Addendum ADD#4

Project Name: Verona Housing

Addendum #3

Structural Addendum #3

A004

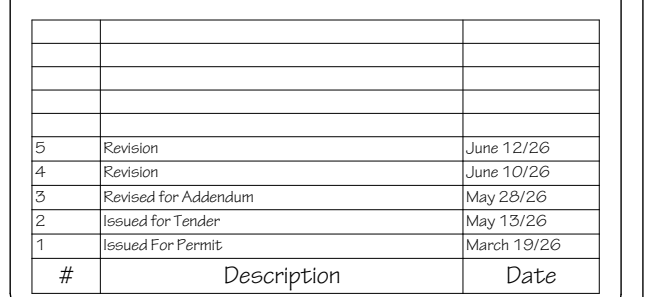
- a. A004: Frame Type 'C' with fire-rated sidelite has been added to the frame types for the Common Room.
- b. A651: Details 11 and 14 for balcony framing have been updated to align with the structural drawings.

① 4_S Floor 2
1:96

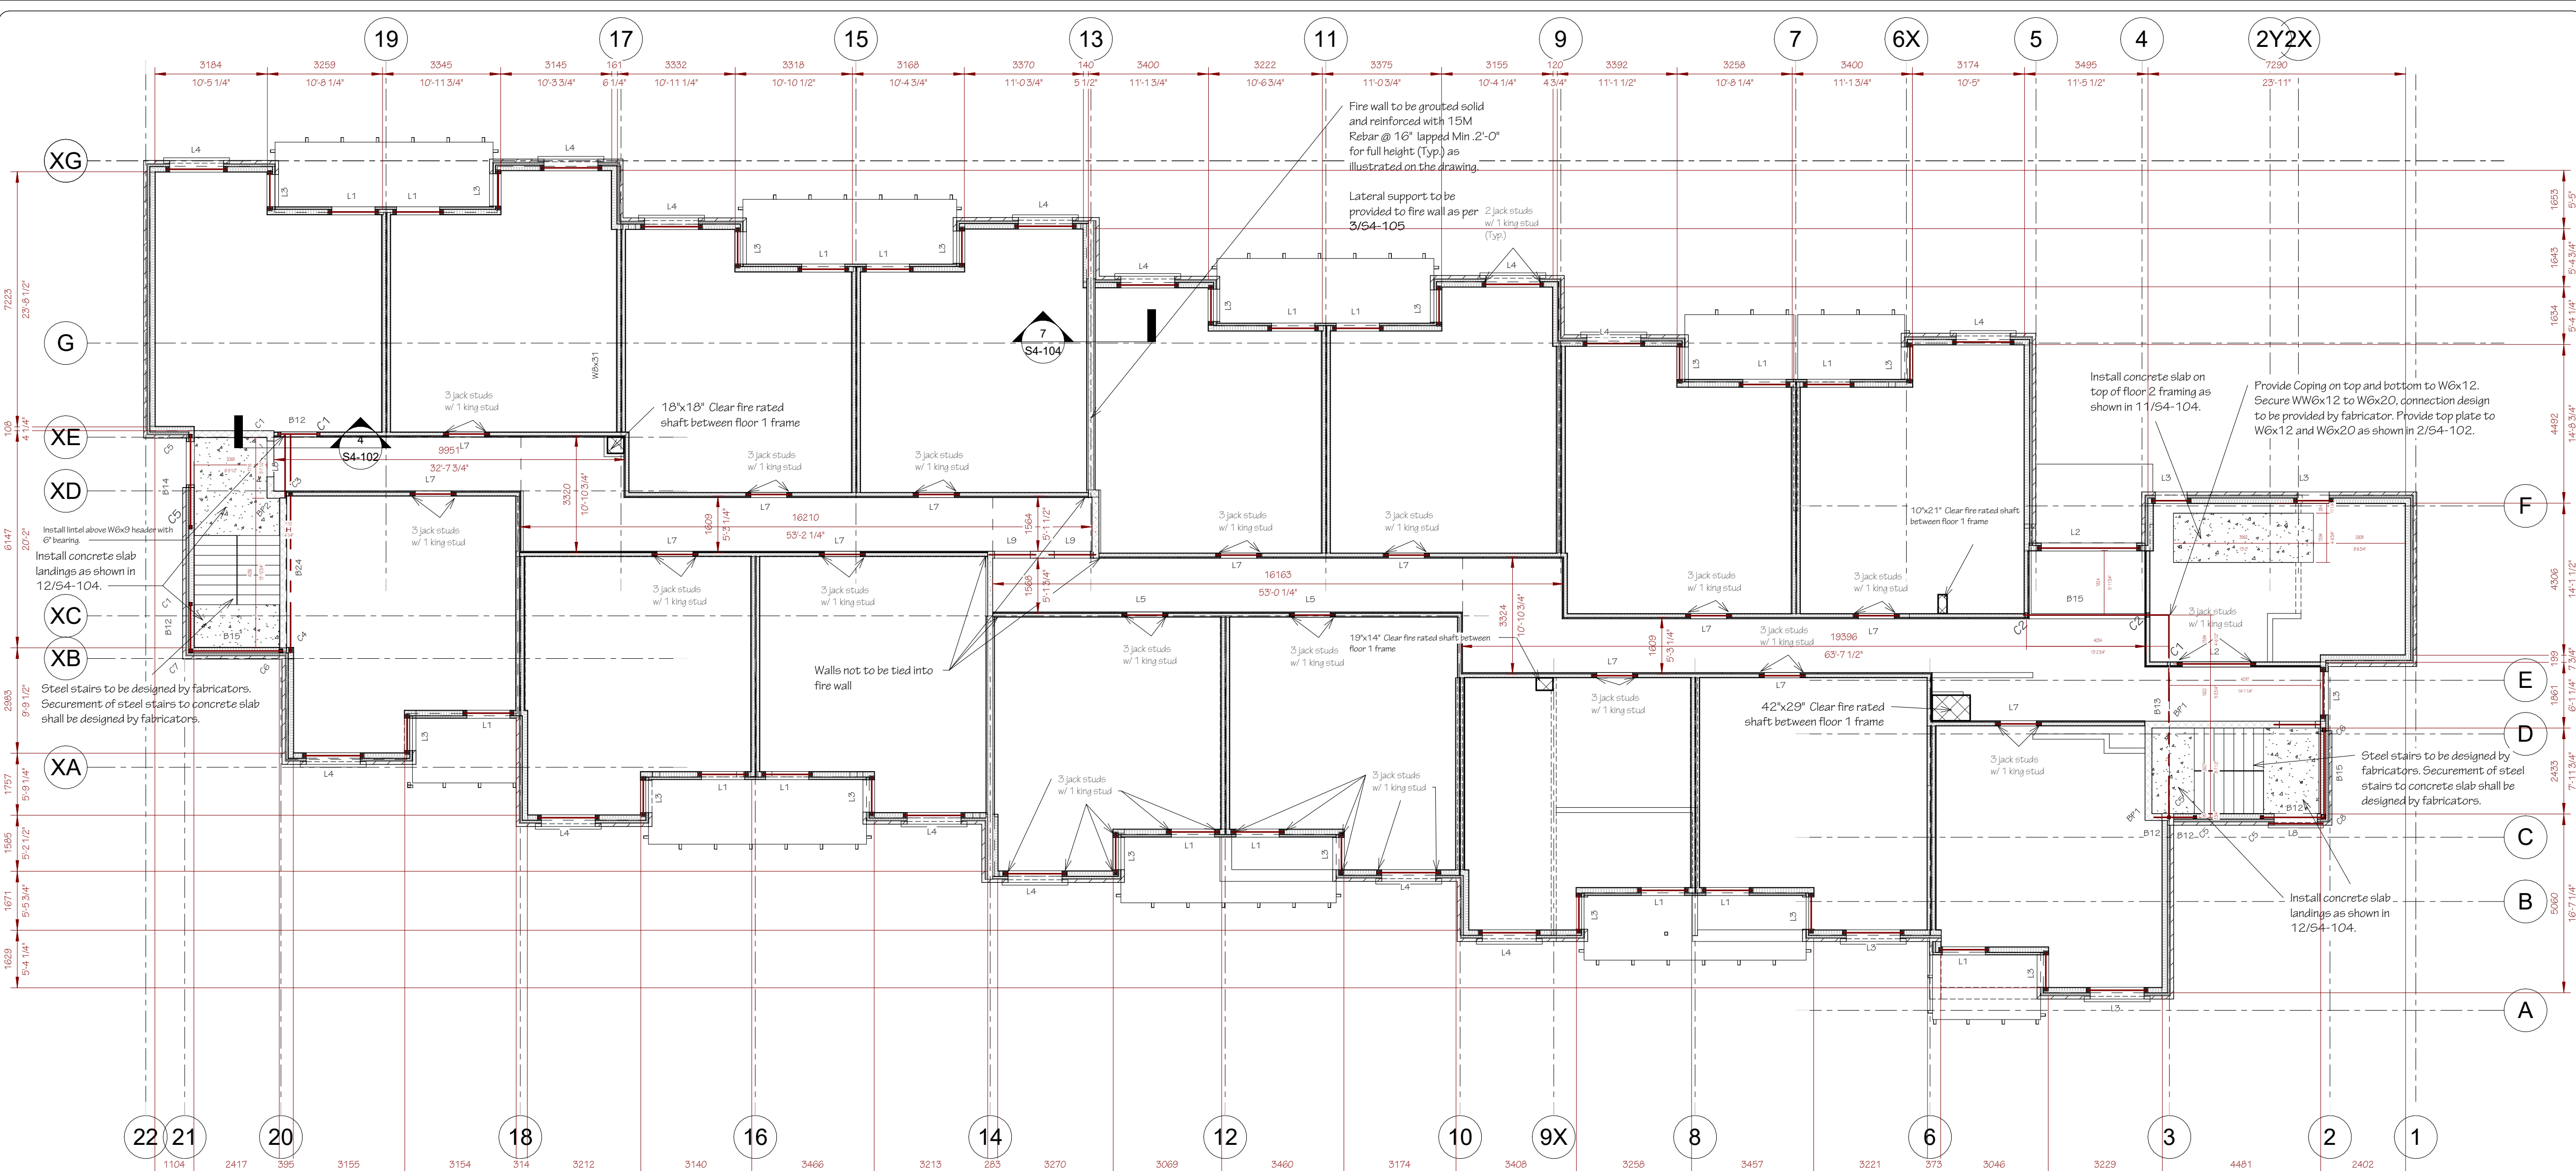
- Extended beams for cantilevered portions around balconies.
- Shifted C channel in detail 2 to be in the center.

⑦ Detail, Beam with Plate Not Centered
1:12

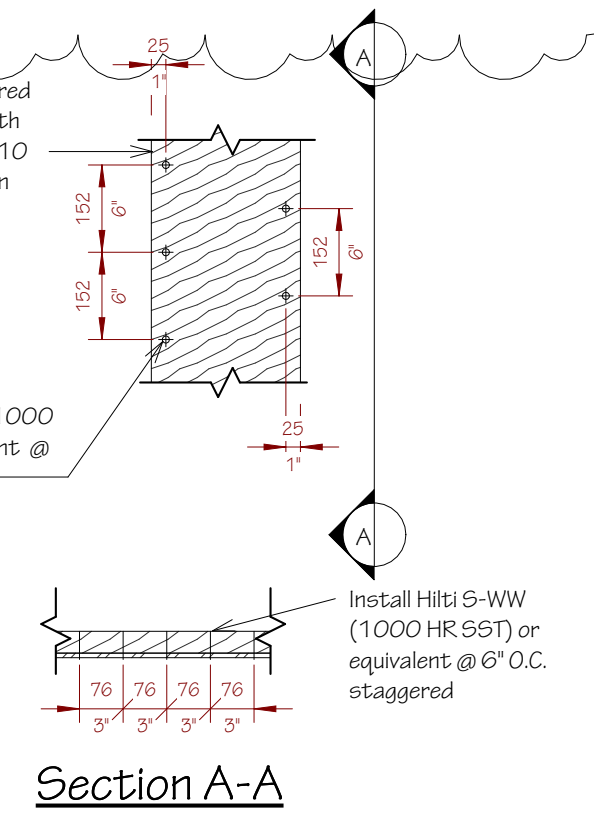
- Revised detail 7 to make the steel beam not interfere with the finishes.
